Interactive comment on “Statistical downscaling of climate data to estimate streamflow in a semi-arid catchment” by S. Samadi et al.

Anonymous Referee #1

Received and published: 30 April 2012

Fig. 1. warming projection from HadCM3

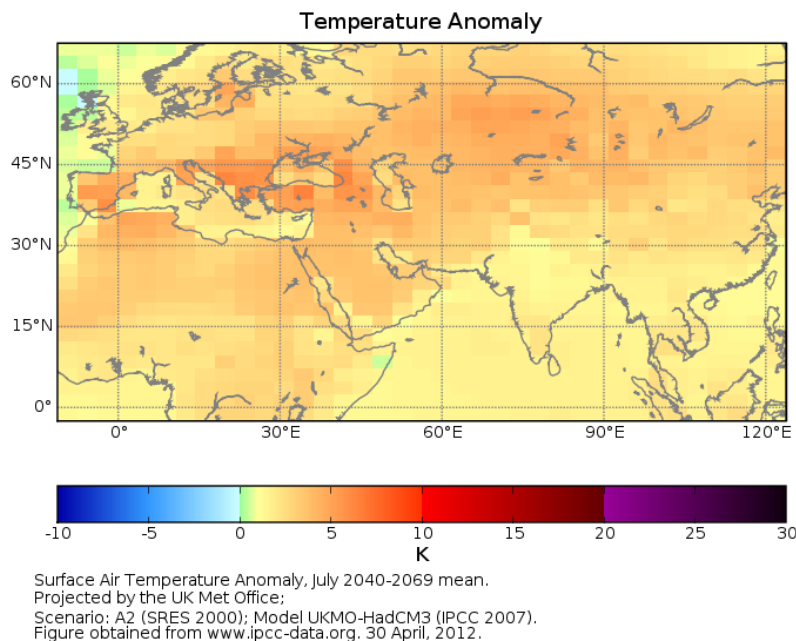
Given the cooling temperature projections, something is obviously fundamentally wrong here. The attached Fig. 1 from the IPCC demonstrates that, instead, HADCM3

projects a warming of about 4-5C for the entire area and not a cooling.
